Village/Town of Mount Kisco Building Department
104 Main Street
Mount Kisco, New York 10549
Ph. (914) 864-0019-fax (914) 864-1085

M E M O R A N D U M

SUBJECT: 40 Grove Barn, LLC– 40 Grove Street
Site Plan Application

DATE: May 5, 2023

L1

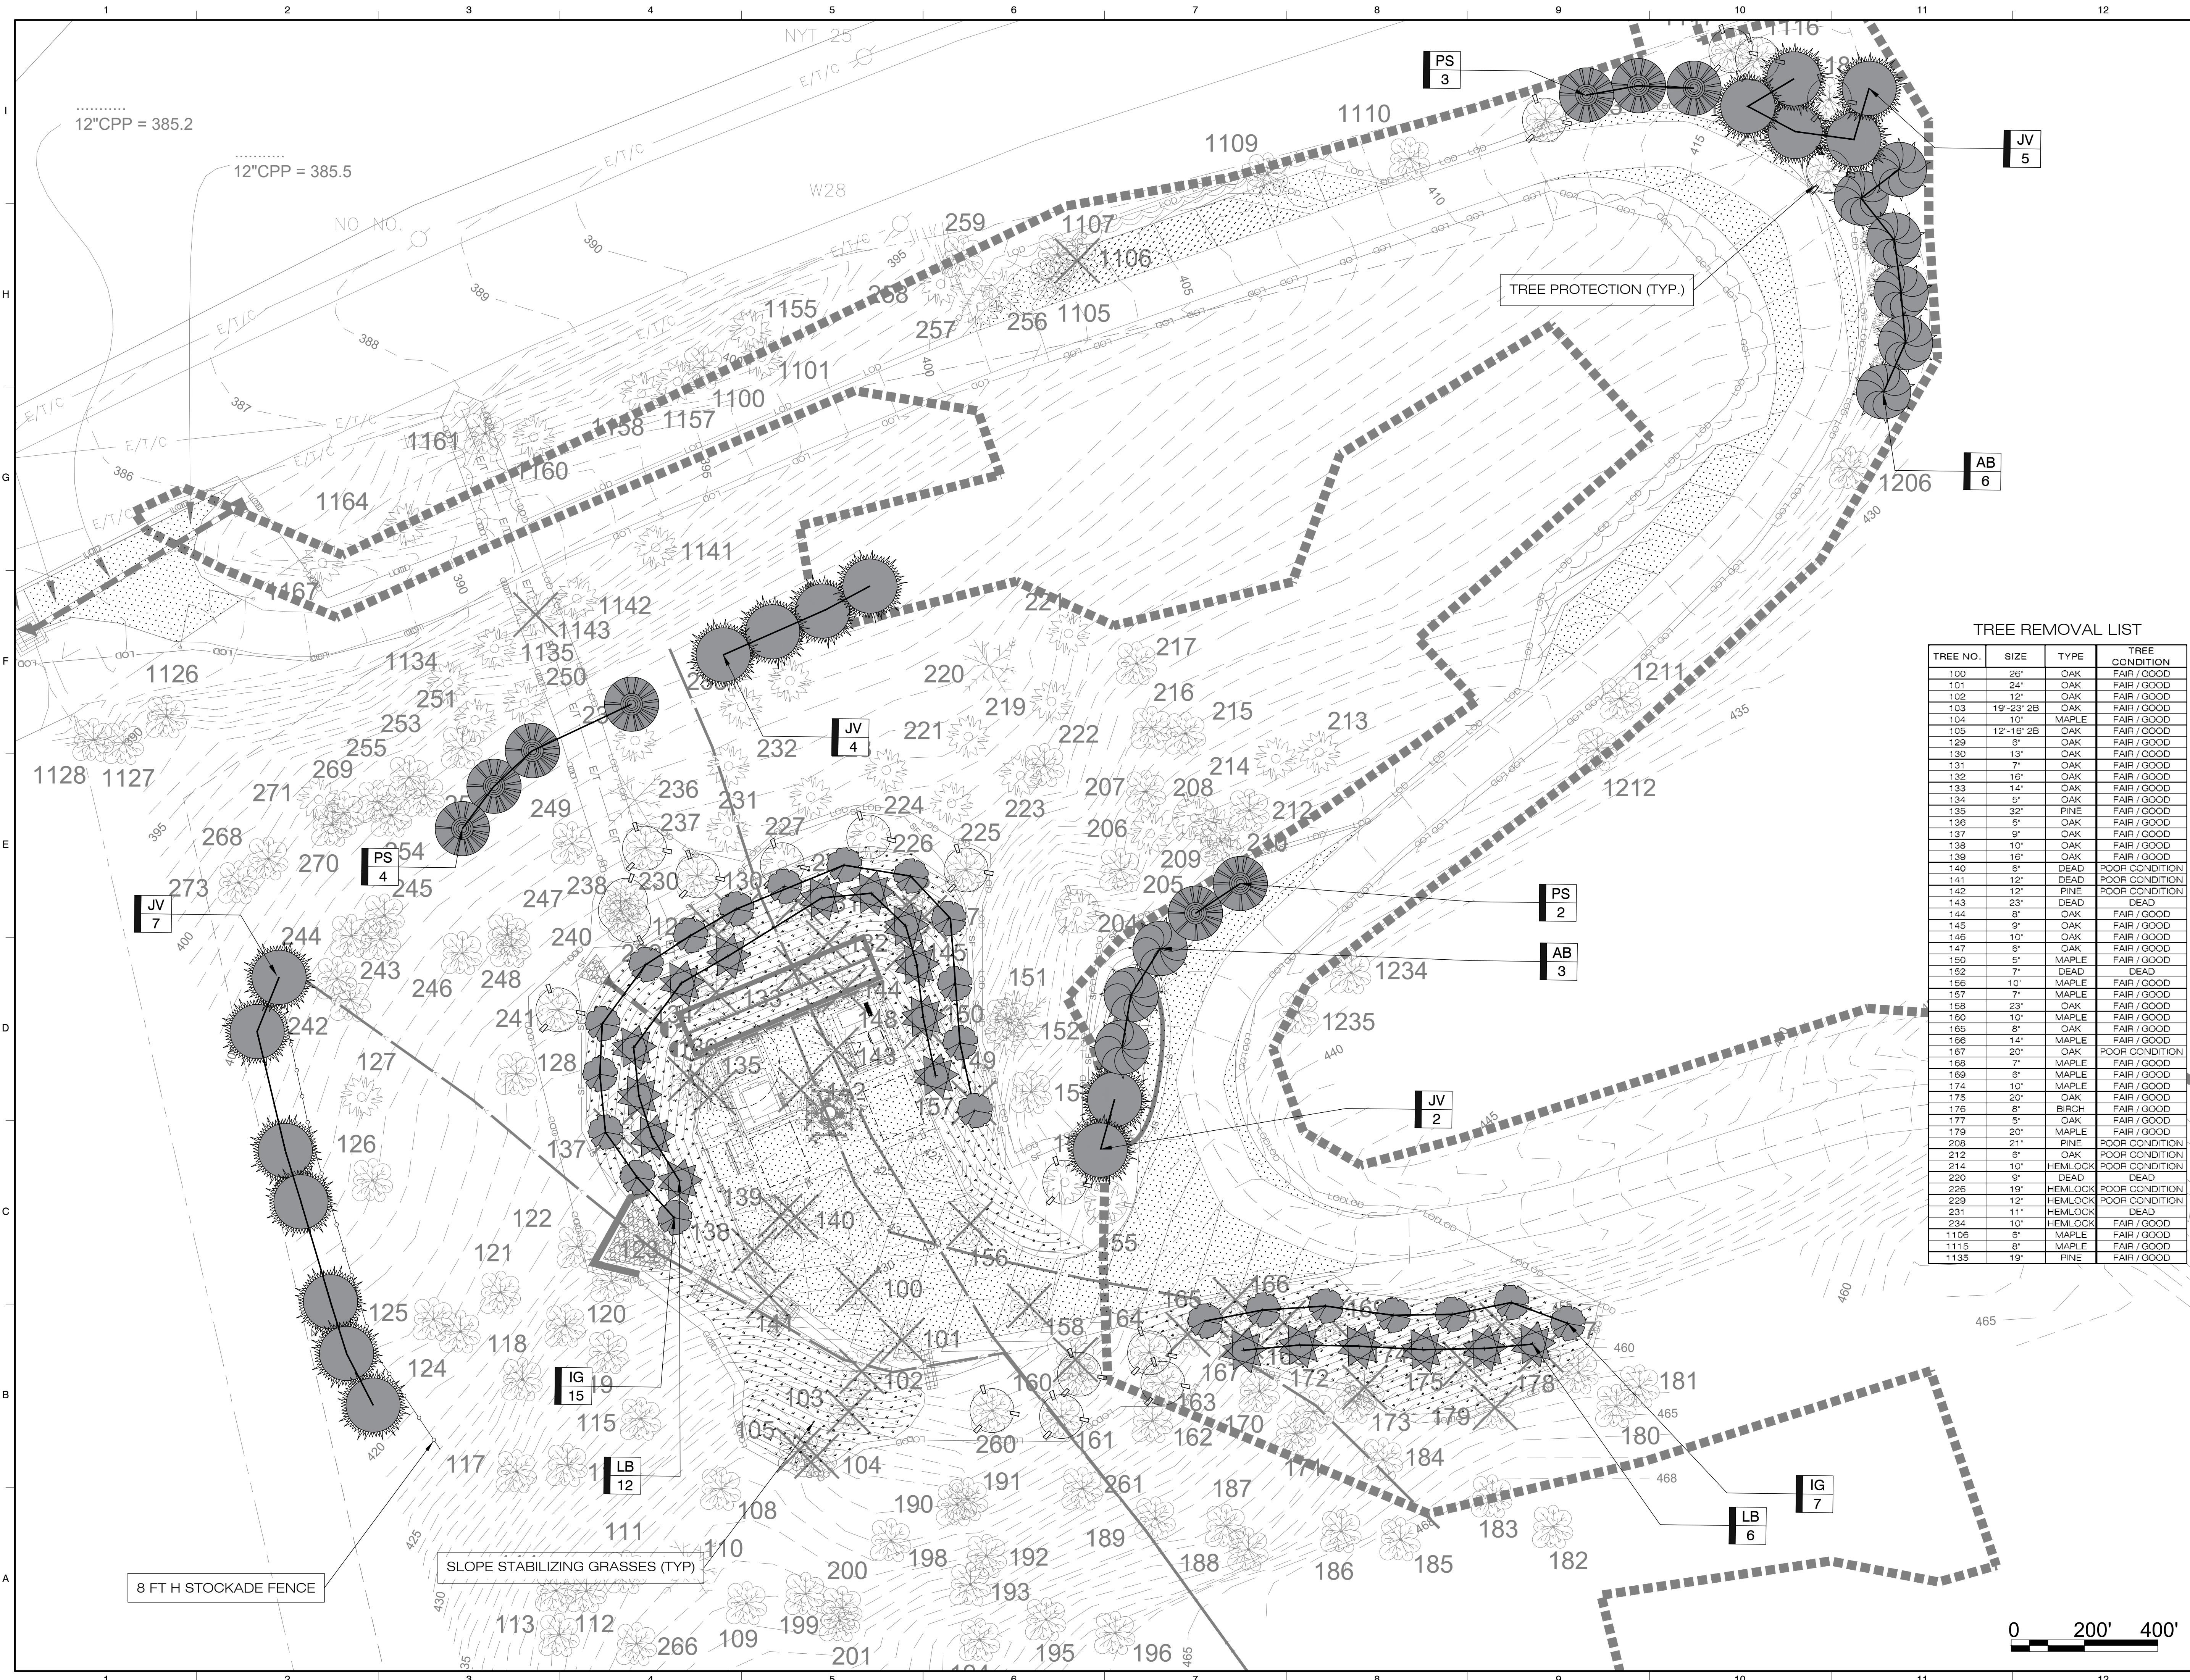
- It is recommended that additional trees be shown as preserved on this and other Site Plan Drawings, including the “key” ones located on the eastern side of the proposed tower / compound location that were noted during the site walks, and along the west side of the proposed compound (see blue arrows in above image).
Based on the reconfiguration of the access drive, the tower and the compound, the key trees on the east side of the compound have been preserved. Additional Landscaping has been proposed on the revised drawings (see Drawing L1).

Based on the reconfiguration of the access drive, the tower and the compound, the key trees on the east side of the compound have been preserved. Additional Landscaping has been proposed on the revised drawings (see Drawing L1).
A Tree Preservation Plan dated April 11, 2023 was prepared by Saratoga Associates (Landscape Architects) and included as Drawing sets L1 and L2
